ADDENDUM No. 3
FOR
LINK – Multi-Use Development
BID PACKAGE – All Trades

Date of Issue: April 24, 2023

LINK – Addendum #3 Narrative

4/21/23

1 STAIR 2 - FIRST FLOOR PLAN
1/4" = 1'-0" REFERENCE: 1/A501A

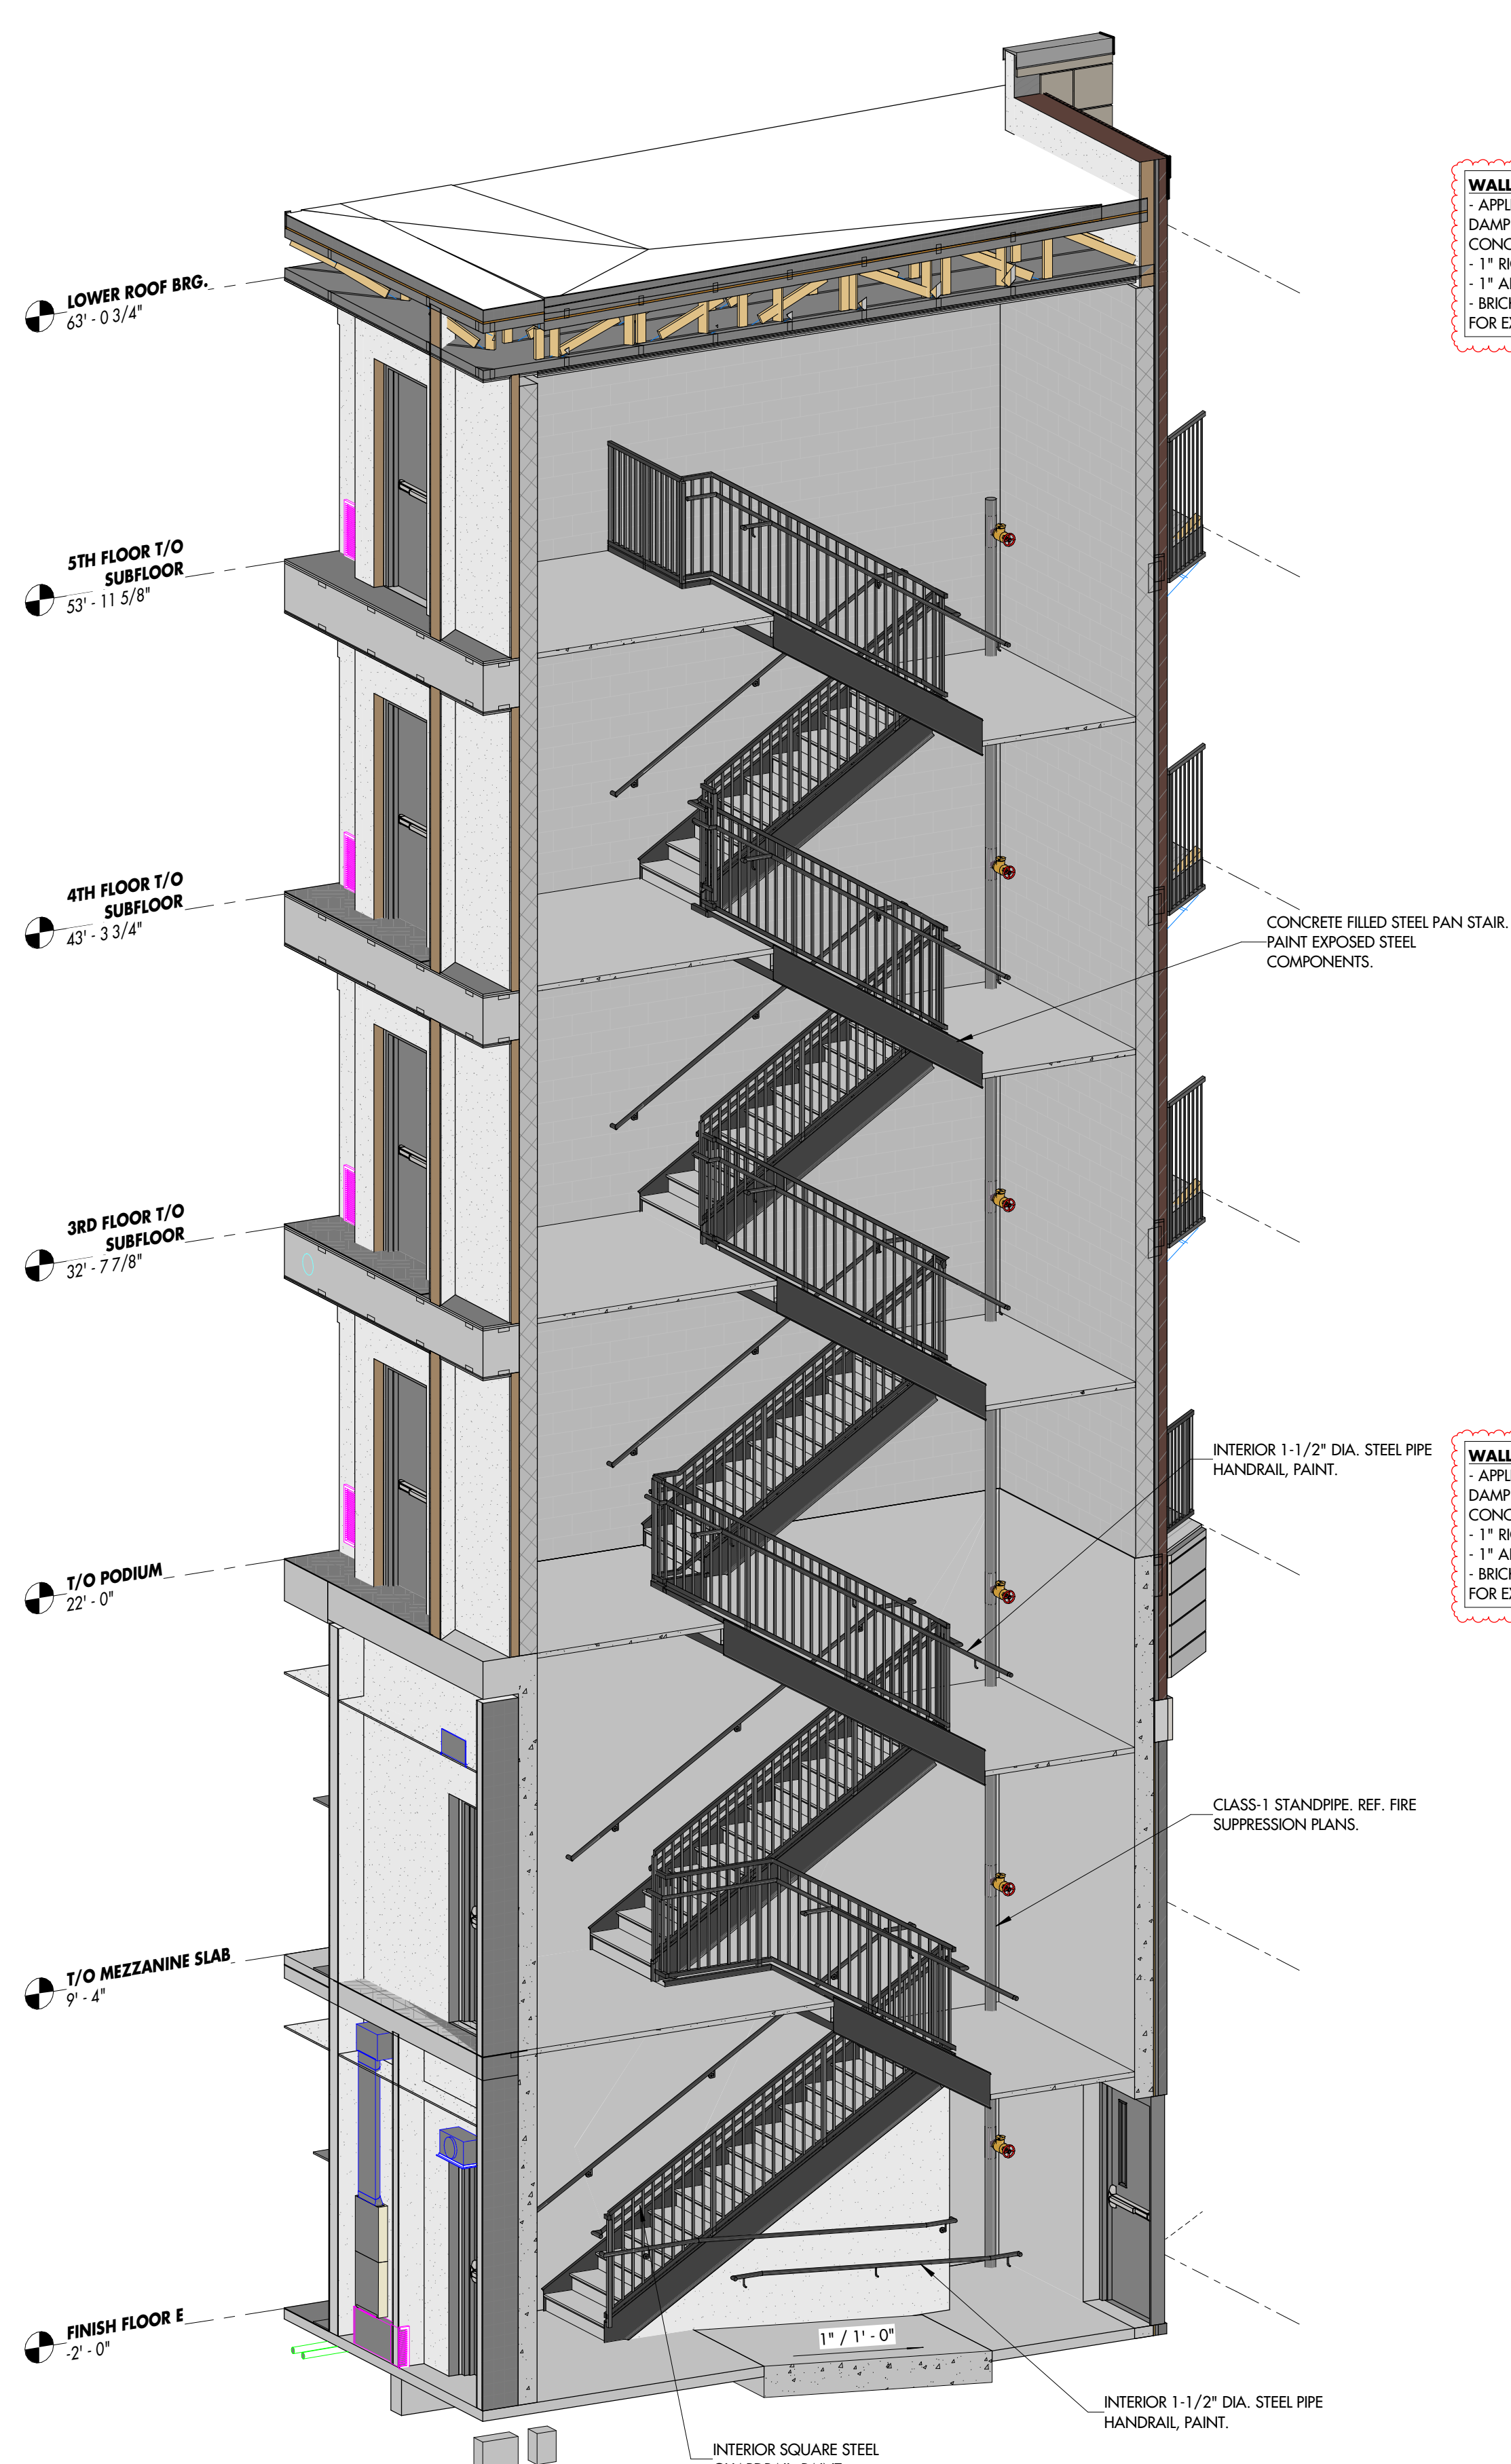
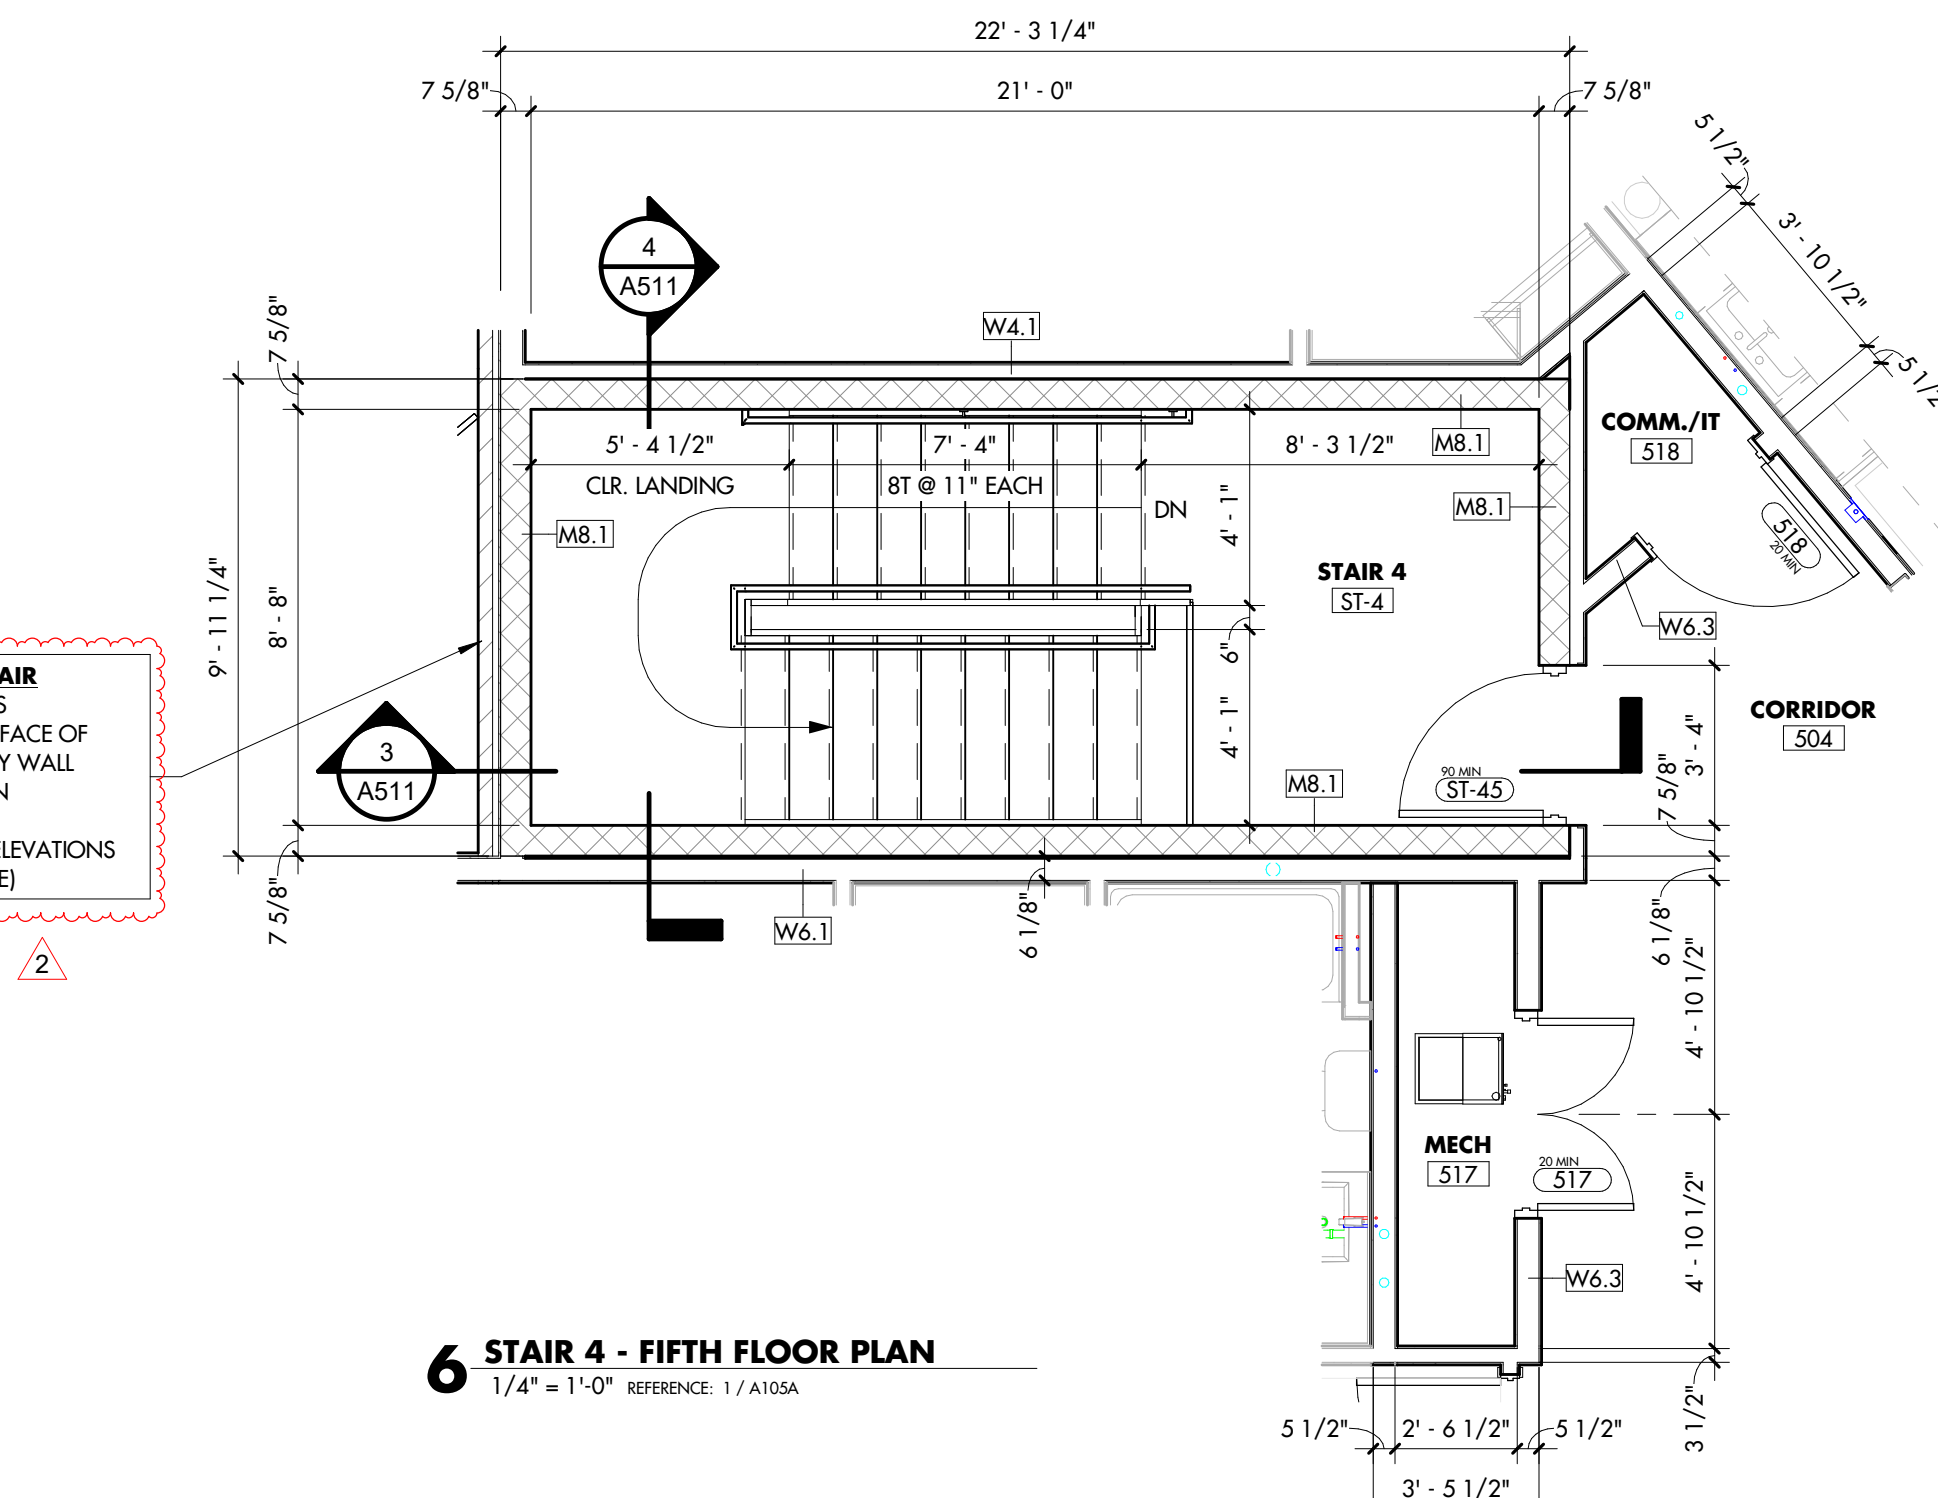
- A504
 - Clarified exterior wall construction at stair.
- A601
 - Revised door finishes.
- A602
 - Revised door finishes.
 - Revised pre-hung unit door heights.
